[Docket No. FAA-2010-1101; Directorate Identifier 2009-CE-013-AD]

**Airworthiness Directives; Cessna Aircraft Company Models 150, 152, 170, 172, 175, 177, 180, 182, 185, 188, 190, 195, 206, 207, 210, T303, 336, and 337 Airplanes**

**ACTION:** Notice of proposed rulemaking (NPRM).

Figure 1. Diameter of seat pin locking engagement hole

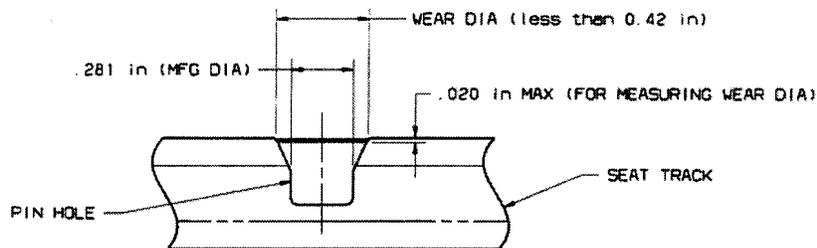
(4) Inspect the diameter of each seat locking pin engagement hole in the pilot and copilot seat rails for excessive wear. Due to wear on the rail surface at the hole opening, we allow this measurement 0.020 of an inch

below the surface of the rail. You must take this measurement somewhere between the surface of the rail or no more than 0.020 of an inch below the surface of the rail.

(i) If the diameter of any of the holes is 0.42 of an inch or more (see figure 1), before further flight, replace the rail.

Figure 2. Seat locking pin depth engagement

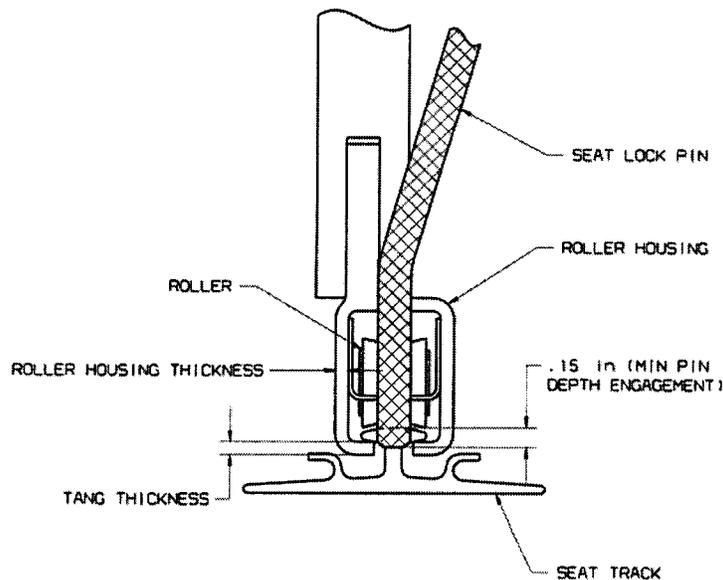
(2) Lift up the forward edge of each seat to eliminate vertical play of the seat locking pin

in the engagement hole, and from this position, inspect the depth of engagement of each seat locking pin (see figure 2). If the rail is worn, this depth is measured from the worn surface, not the manufactured surface.

(i) If engagement of any of the seat locking pins measures less than 0.15 of an inch, before further flight, replace or repair any seat components necessary to achieve a seat pin engagement of a minimum of 0.15 of an inch.

**Figure 3. Closeup of seat roller housing and tang thickness**

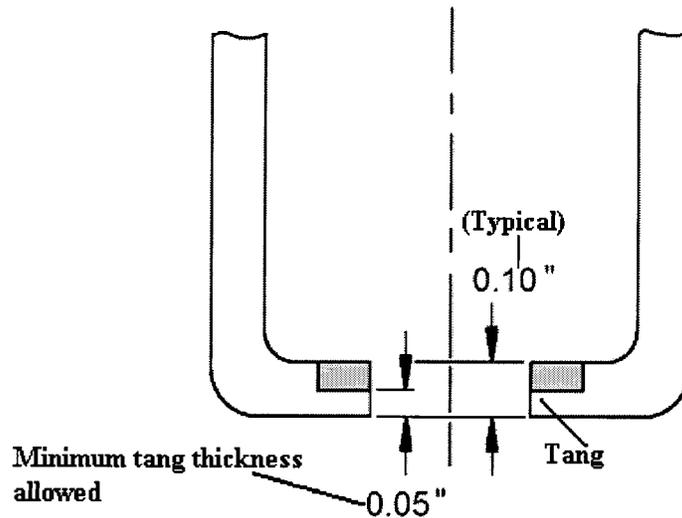
(6) Inspect the thickness of the tang (see figure 2 and figure 3). Due to wear of the tang chafing against the seat rail, measure the tang thickness where the tang inner edges contact the seat rail.

(i) If the tang thickness measures less than 0.05 of an inch, before further flight replace the roller housing.

**Figure 4. Closeup of seat roller housing and tang gap width**

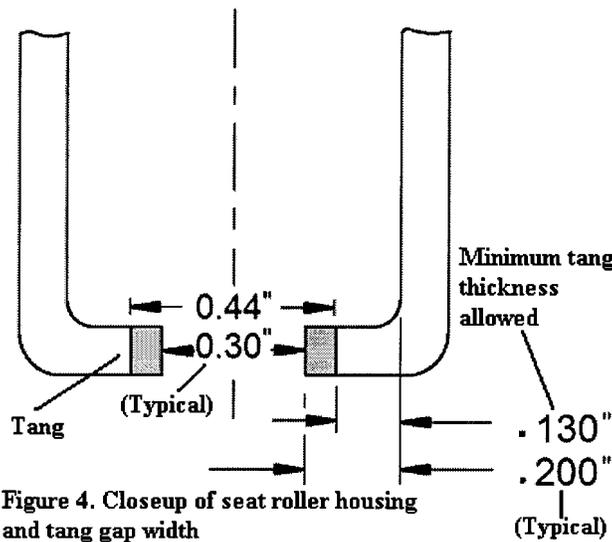
(7) Inspect the inner edges of the tangs. Due to wear or deformation of the tangs, measure the distance from one tang inner

edge to the other tang inner edge (see figure 4).

(i) The maximum distance allowed between tang edges is 0.44 inches. If the

distance between tang inner edges measures 0.44 of an inch or more, before further flight, replace the roller housing.

**Figure 5. Seat rail**

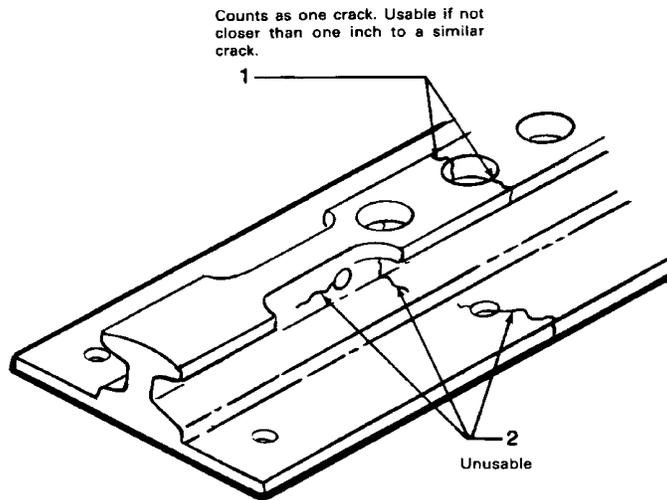
(9) Visually inspect the seat rails for cracks.

(i) If there are seat rail cracks that exceed the crack criteria in figure 5, before further flight, replace the seat rail.

**REPLACE SEAT RAIL WHEN:**

- (1) Any portion of web or lower flange is cracked (index 2).
- (2) Any crack in crown of rail is in any direction other than right angle to length of rail.
- (3) Number of cracks on any one rail exceeds four, or any two cracks (index 1) are closer than one inch.
